RFI #: 121  
Date: 5/18/2012  
Job: EB-02 Keller Springs Lofts  
Phone: 877-777-5115

Subject: Floor Truss Support at A2-SP Unit

RFI #: 142  
Date: 6/6/2012  
Job: EB-02 Keller Springs Lofts  
Phone: 877-777-5115

Subject: Structural Steel Dimensions at Cantilever

Drawing: S2.23 Spec Section:  
Cost Impact: None Schedule Impact:

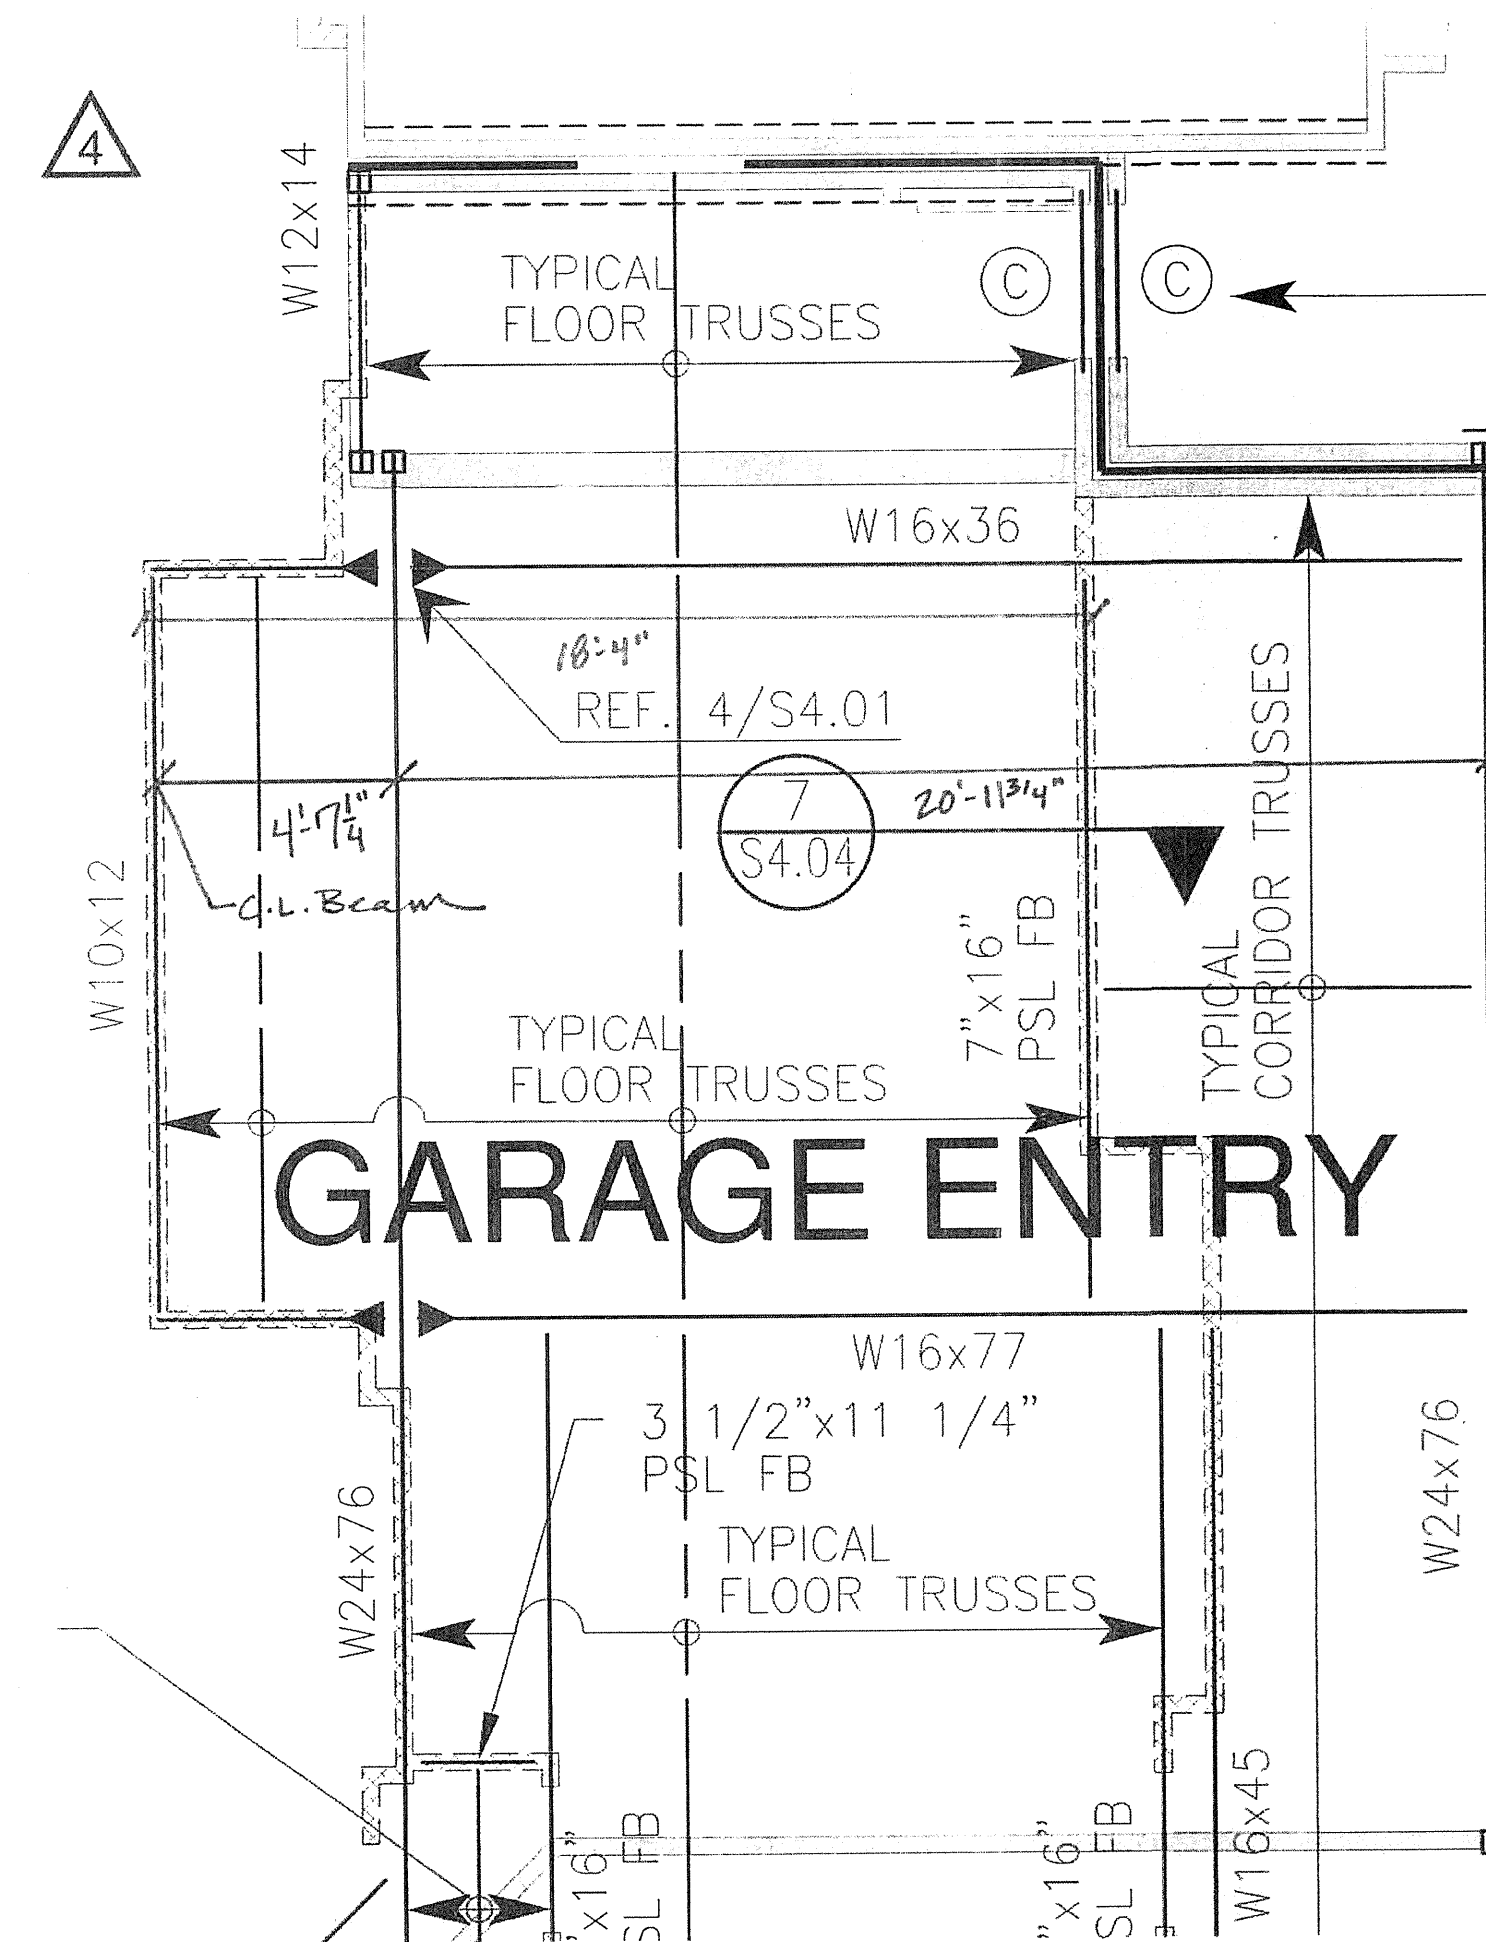
**Request:** Date Required: 6/8/2012  
Please provide the dimension of the cantilevered beams clouded on the attached drawings. This is over the garage entry. We have requested this info from BGO and were told that PPO should provide it.

Please see attached. Note that the dimension is based on the architectural dimension shown in red and a corridor width of 7'-4". We recommend that all parties involved review the dimension prior to beam construction to ensure that we are all in agreement on the dimensions.
